PIC32MZ Graphics (DA) Family Silicon Errata and Data Sheet Clarification

The PIC32MZ Graphics (DA) family devices that you have received conform functionally to the current Device Data Sheet (DS60001361F), except for the anomalies described in this document.

FIGURE 1: Posc CRYSTAL CIRCUIT

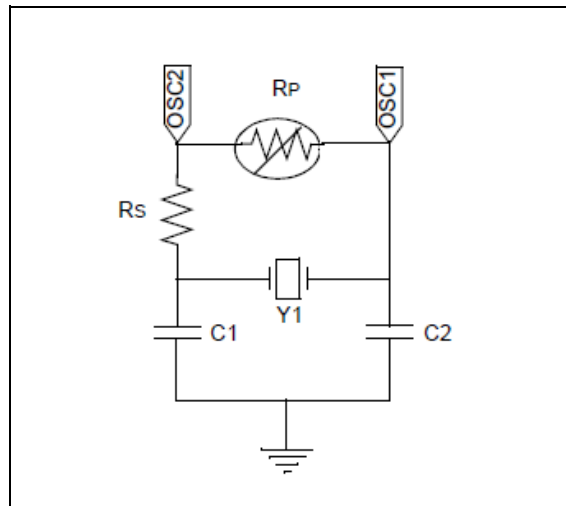
The POSC has been tested in a normal power-up sequence and supports specific crystal operation.

The Primary Oscillator (POSC) has been characterized to operate at 8 MHz and 12 MHz when the circuit shown in Figure 1 is implemented, and the operating conditions listed in Table 3 are met.
